## Sun Path Products, Inc. Service Bulletin SPSB # 03032000 Revision B

FIGURE 4

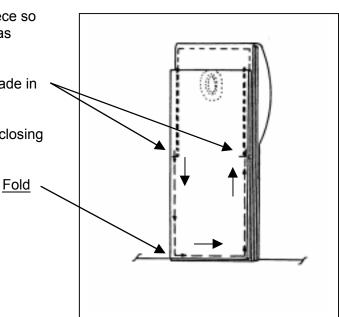
Lay Type 12 towards grommet and fold it so that the fold lines up with the top of the grommet.

Mark the top layer of Type 12 directly above the two marks as marked in Fig 2 & 3.

Using a straight stitch machine sew along the edge of the tape from a mid-bartack mark up to and one stitch over the fold and return to the mark.

Sew only to the layers of Type 12 that the grommet is set through. Do  $\underline{NOT}$  sew through the back part of the closing loop retainer. (Continuous loop or short cover).

Repeat on other side [Fig 4].

# FIGURE 5

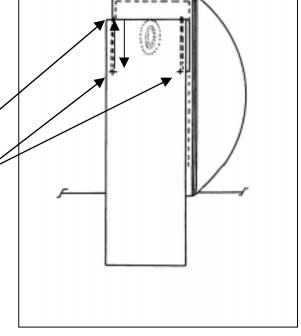
5. Lay closing loop retainer flat and fold unsewn piece so that the fold is as close to the reserve container as possible.

Sew around three sides from <u>mark to mark</u> as made in Fig 4.

Be careful not to sew closed the opening for the closing loop. [Fig 5].

FIGURE 6

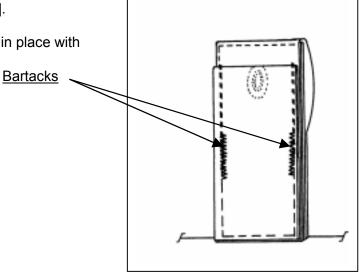
Replace bartacks or zig-zag new locking stitches in same place as the ones taken out. [Fig 6].
NOTE: The short cover must be secured in place with

the bartacks.
